FPS **MOBILITY AND TRANSPORT**
DG **ROAD TRANSPORT AND ROAD SAFETY**

Changes (substantial) WP1 on the EGRSS
final report & proposal for Annex 1 & 3

Issue 25

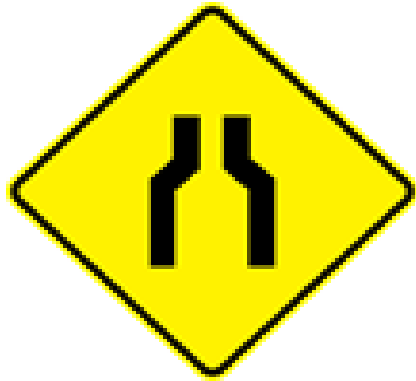
1. The depictions of E, 11; and E, 16 signs do not follow the general characteristics of E signs . To this end, the Group recommends changing the depictions to be in line with the general characteristics of E signs (see subsection 1.2 of this document on amendments to Annex 1 and 3 of the Convention, section E, paragraphs II.9 and II.13). **The same goes for the E,15 sign, however, to avoid confusion with the additional panels H, 5 and the use of the symbol of the bus on the G, 18 sign, the E, 15 sign will be kept as is.**

E, 15

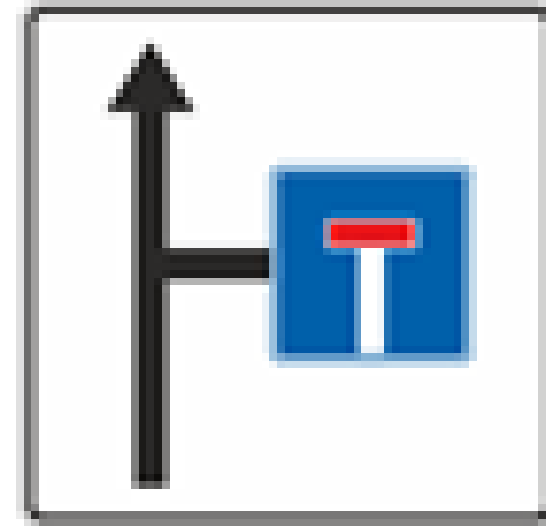
Sign E, 15 will be kept in its present form. As it cannot be mistaken with the advisory itinerary for buses, G, 18 (with the symbol of a bus).
